SUBJECT: Chicago Executive Airport
Wheeling/Prospect Heights, Illinois
Cook County
Illinois Project Number: PWK-5128
SBG Project Number: 3-17-SBGP-TBD
Contract No. PA066
Item No. 04A, September 20, 2024 Letting
Addendum A

NOTICE TO PROSPECTIVE BIDDERS

To revise plans, special provisions and schedule of prices.

CHICAGO EXECUTIVE AIRPORT
 WHEELING/PROSPECT HEIGHTS, ILLINOIS
 CONSTRUCT APRON (NE QUADRANT) AND TAXILANE ACCESS
DRAINAGE PLAN

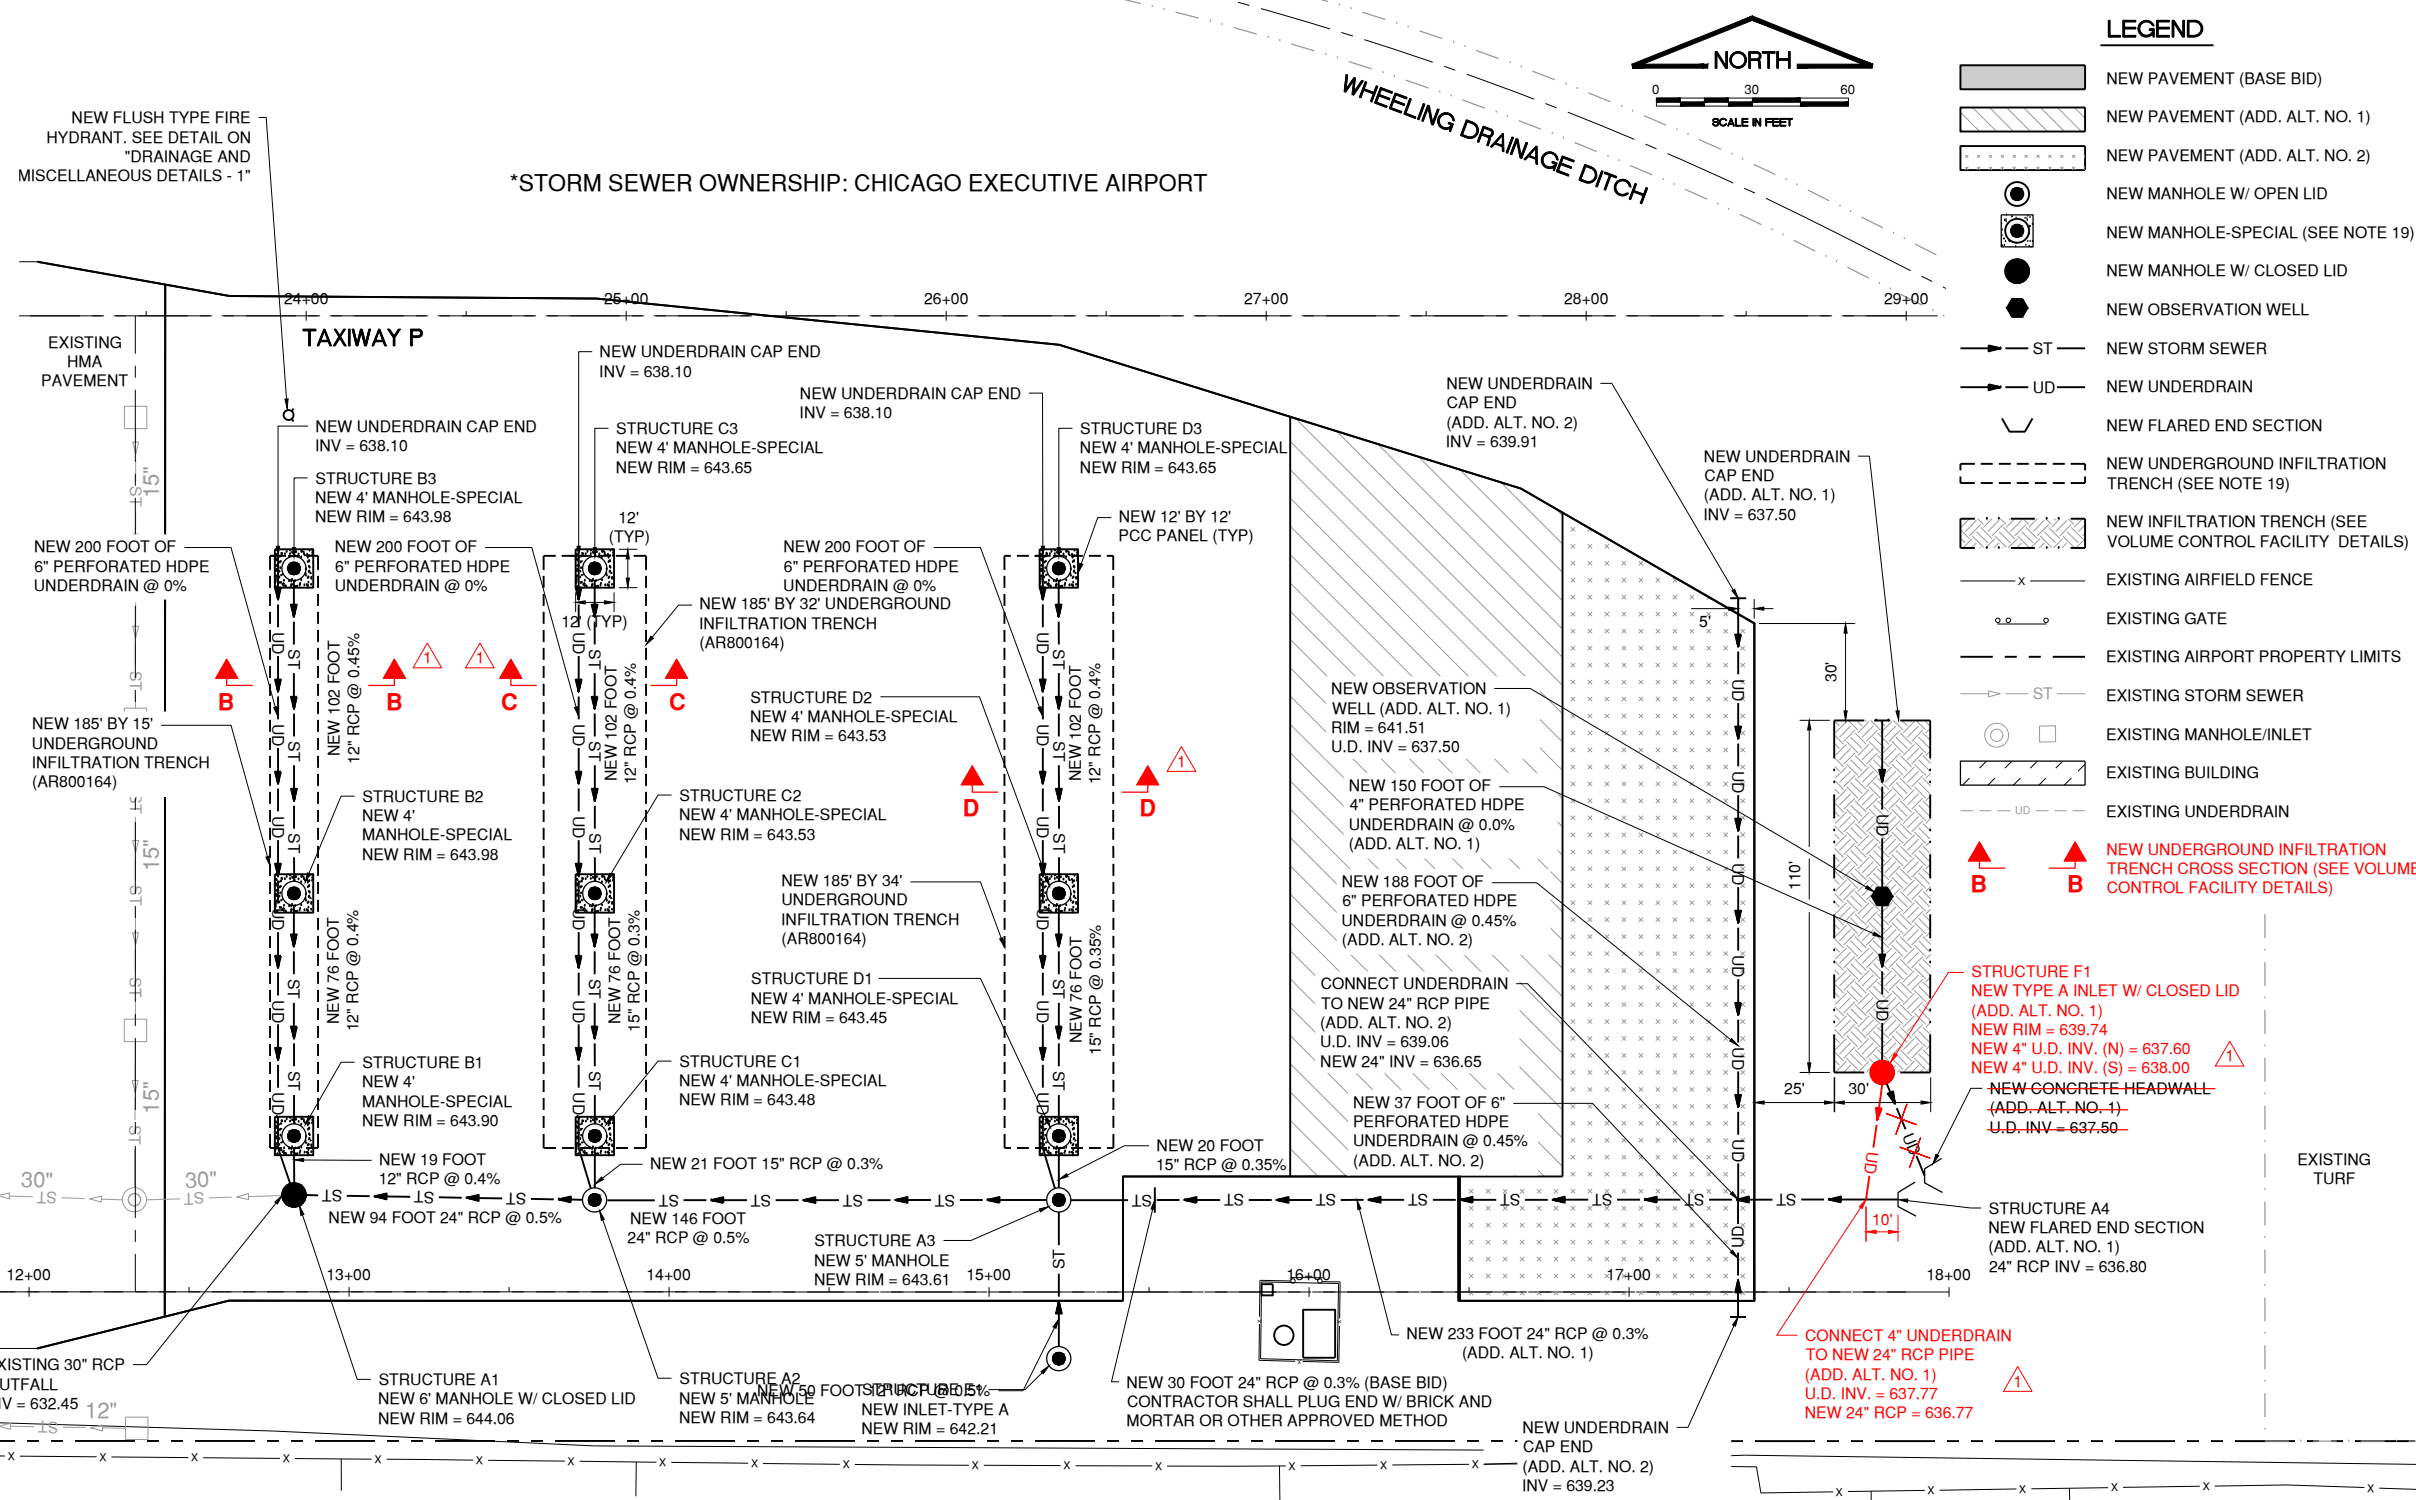
2. Sheet 18 - Drainage and Miscellaneous Details – 3 (revised plan sheet not included)
 - a. Delete Concrete Headwall for Pipe Underdrains detail.
3. Sheet 20 - Replace Drainage Plan with Revised Drainage Plan

- a. Base Bid: Added underground infiltration trench cross section notations.
 - b. Additive Alternate No. 1: Added Structure F1 Type A Inlet, revised underdrain routing and deleted Concrete Headwall.

CHICAGO EXECUTIVE AIRPORT
WHEELING/PROSPECT HEIGHTS, ILLINOIS
CONSTRUCT APRON (NE QUADRANT) AND TAXILANE ACCESS
STORM SEWER PROFILES

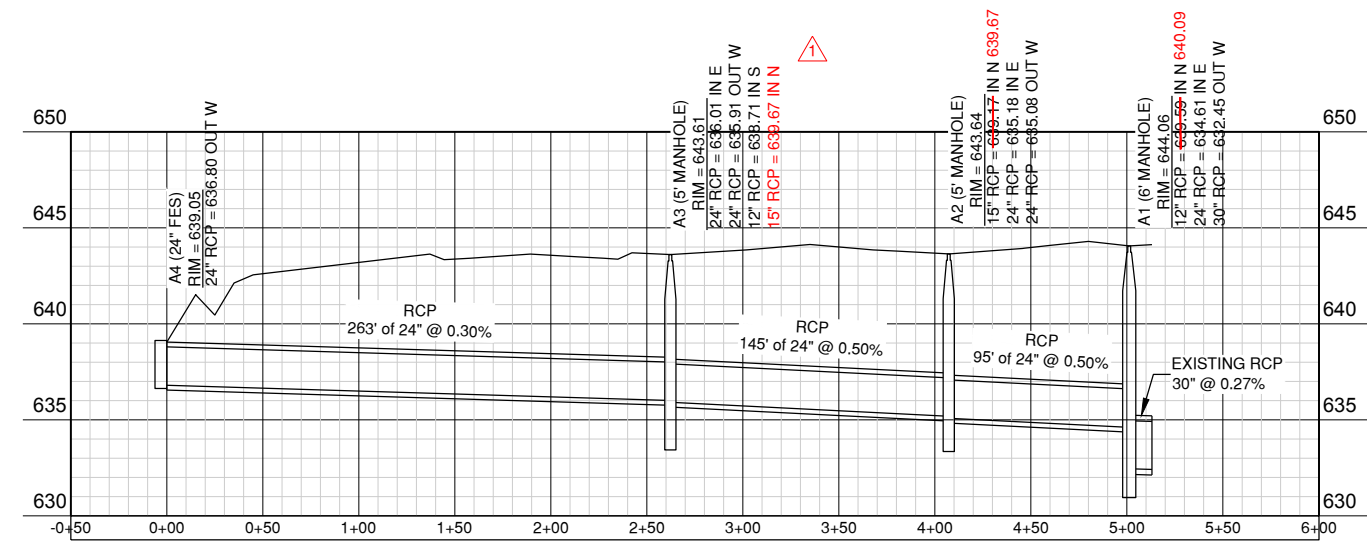
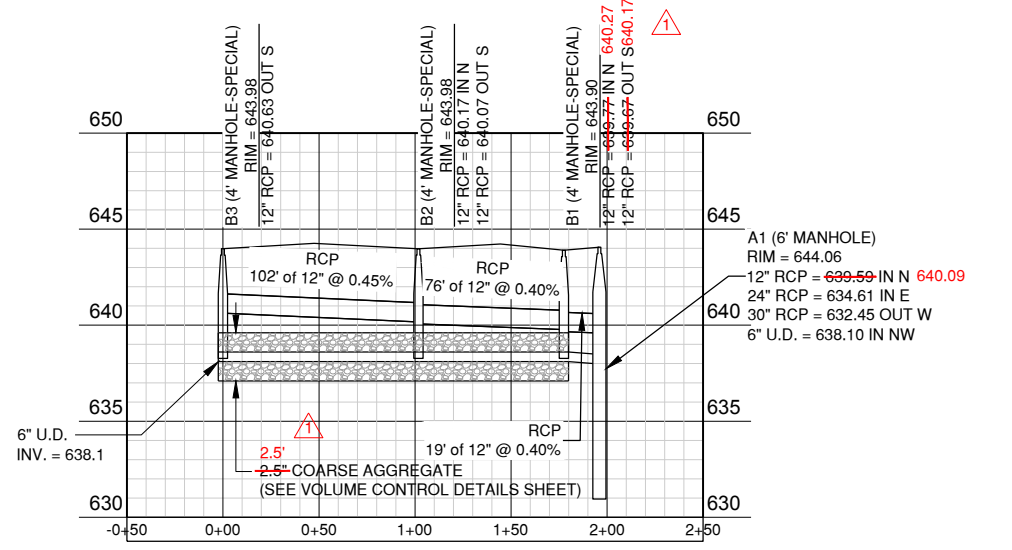
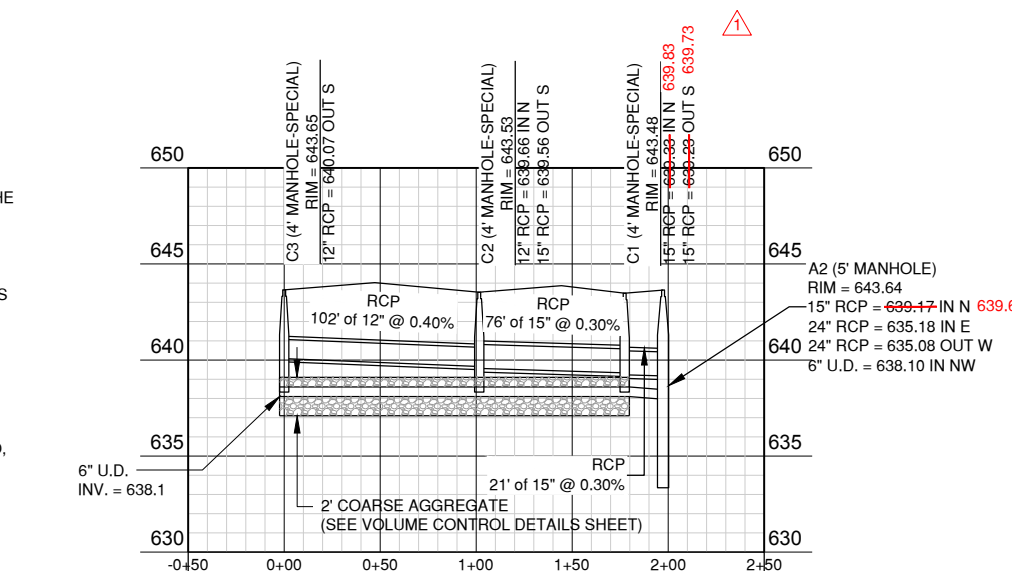
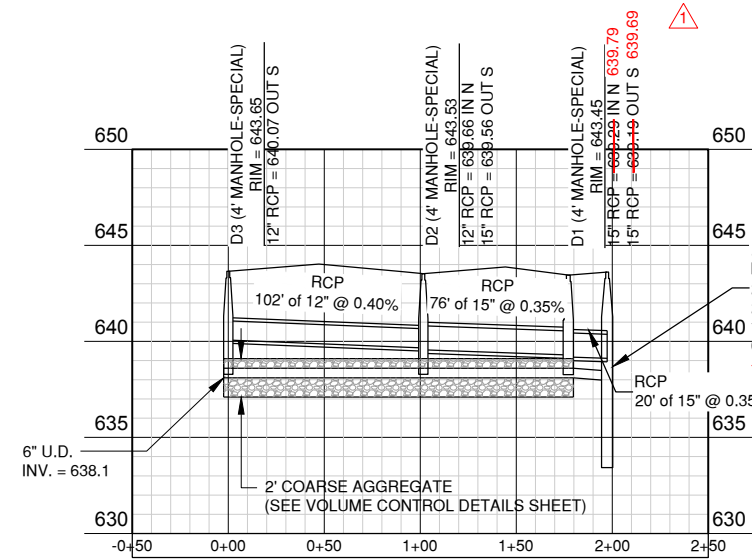
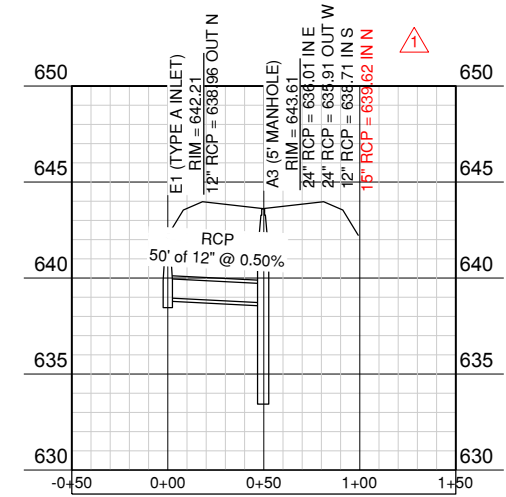
4. Sheet 21 - Replace Storm Sewer Profiles with Revised Storm Sewer Profiles
 - a. Base Bid: Revised storm sewer inverts in profiles and in Structure Schedule.

- b. Additive Alternate No. 1: Added Structure F1 Type A Inlet.
5. Sheet 26 – Replace Volume Control Facility Details with Revised Volume Control Facility Details

CHICAGO EXECUTIVE AIRPORT
WHEELING/PROSPECT HEIGHTS, ILLINOIS
CONSTRUCT APRON (NE QUADRANT) AND TAXILANE ACCESS
VOLUME CONTROL FACILITY DETAILS

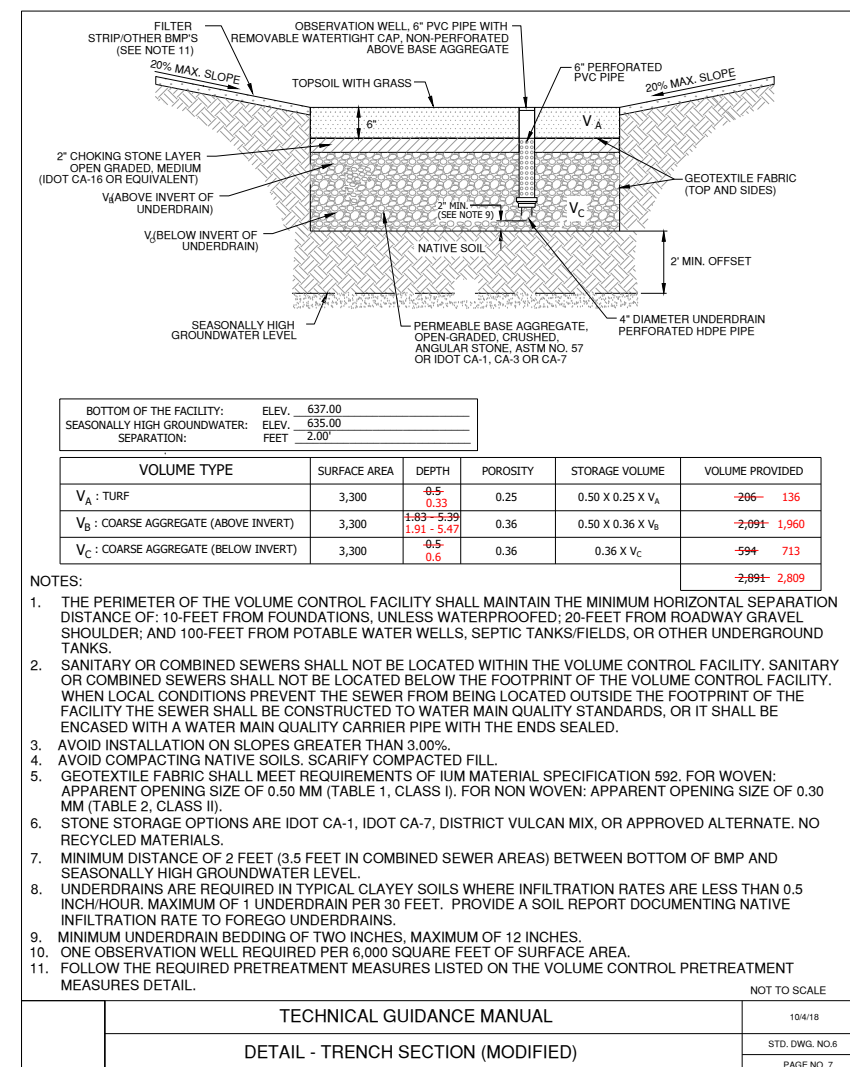
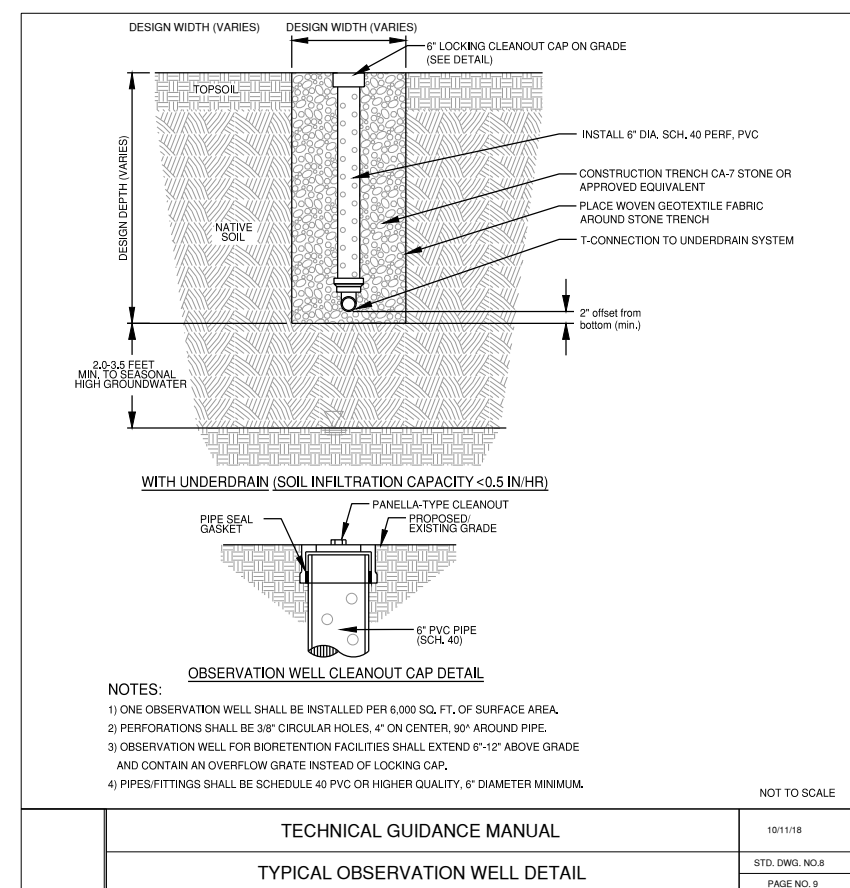
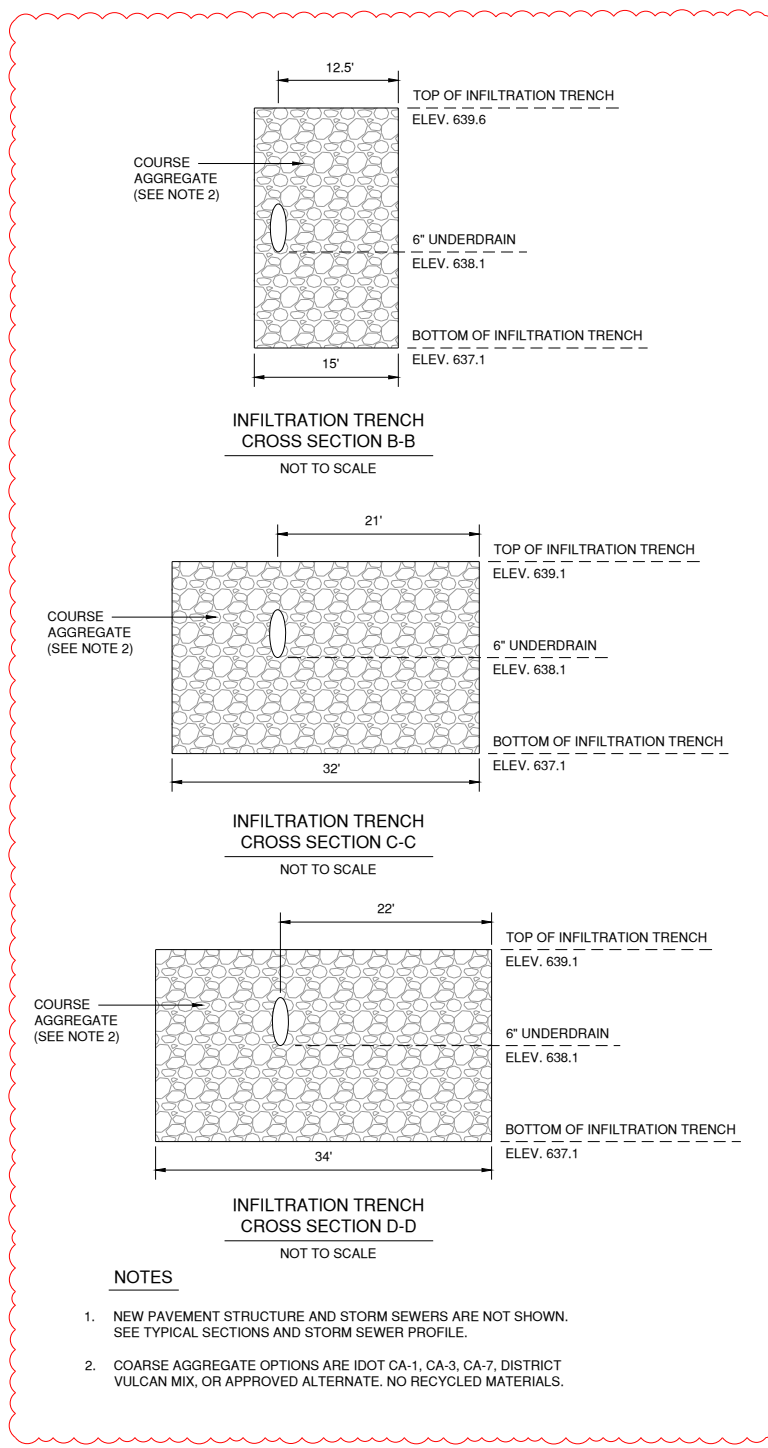
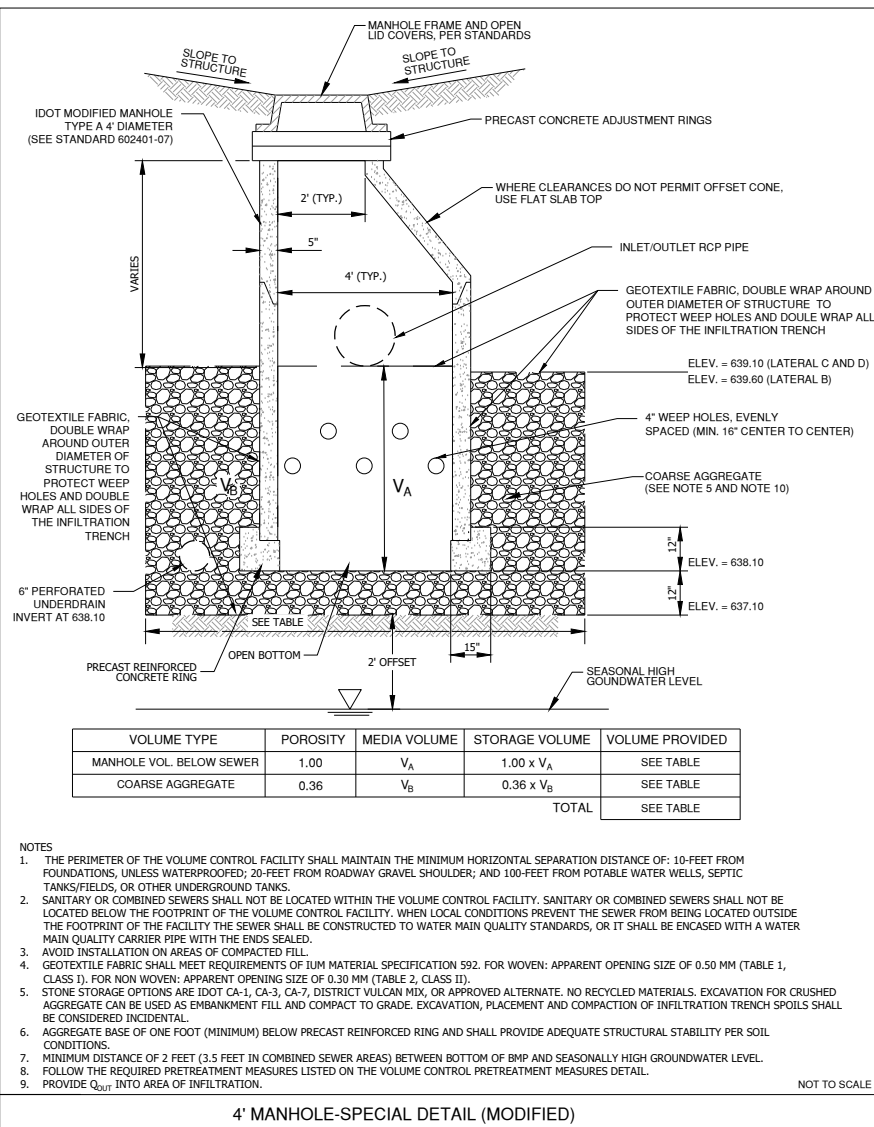
- a. Base Bid: Added Infiltration Trench Cross Sections and revised volume control table for depths and volume provided.
